SUPPORTS AT Y-SPLICES

DESCRIPTION AND USE

1.001 This addendum supplements Section 633-020-201, Issue 4.

Support Spacer
Fig. 11

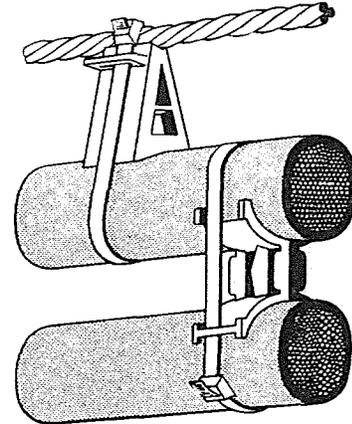
- 2.11 — added
- Fig. 11 — added

2.11 Place and secure the appropriate sized spacer with a C lashed cable support as shown in Fig. 11. After securing the support spacer, trim off the protruding end of the C lashed cable support (black tie).
